Part 2 – Technical Requirements

Application under the *Agricultural Operation Practices Act* for a confined feeding operation, manure collection area, and/or manure storage facility(ies)

NRCB USE ONLY	Application number	Legal land description
<input checked="" type="checkbox"/> Approval <input type="checkbox"/> Registration <input type="checkbox"/> Authorization <input type="checkbox"/> Amendment	LA24034	NE 22-8-25 W4M

Approval LA22031

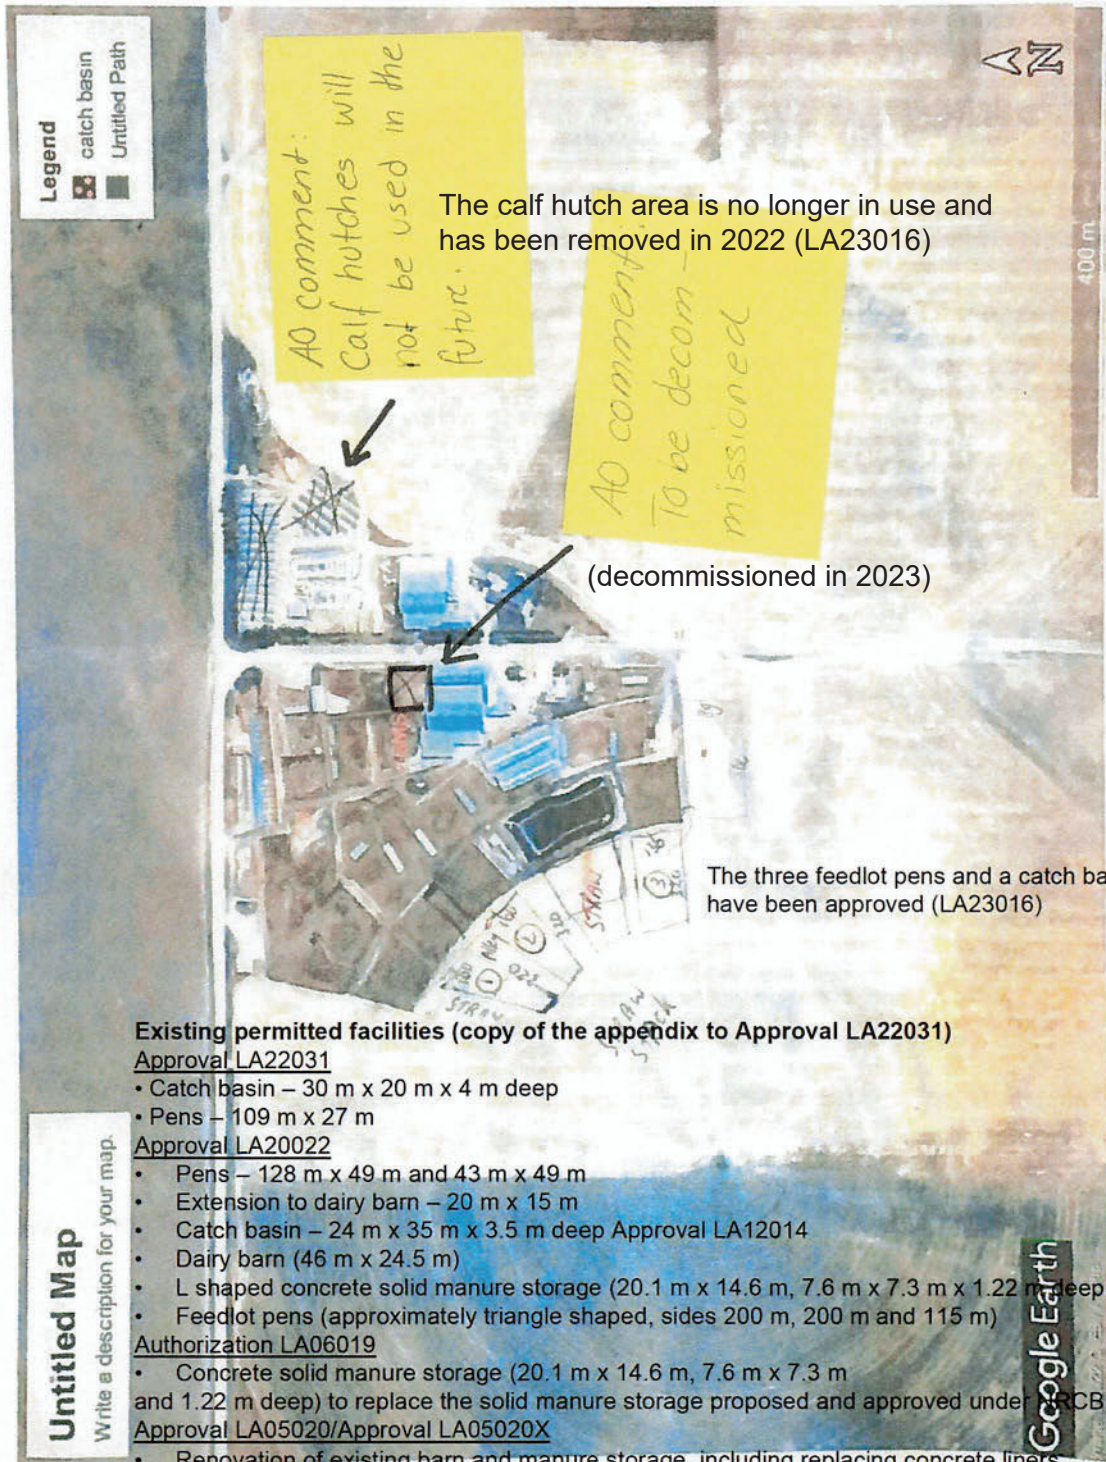
AO note: #6 and #4 are roofs overtop existing pens and therefore do not need a permit.

AO comment:
 Calf hutches will
 not be used in the
 future.

AO comment
 To be decom-
 missioned

The calf hutch area is no longer in use and has been removed in 2022 (LA23016)

(decommissioned in 2023)

The three feedlot pens and a catch basin have been approved (LA23016)
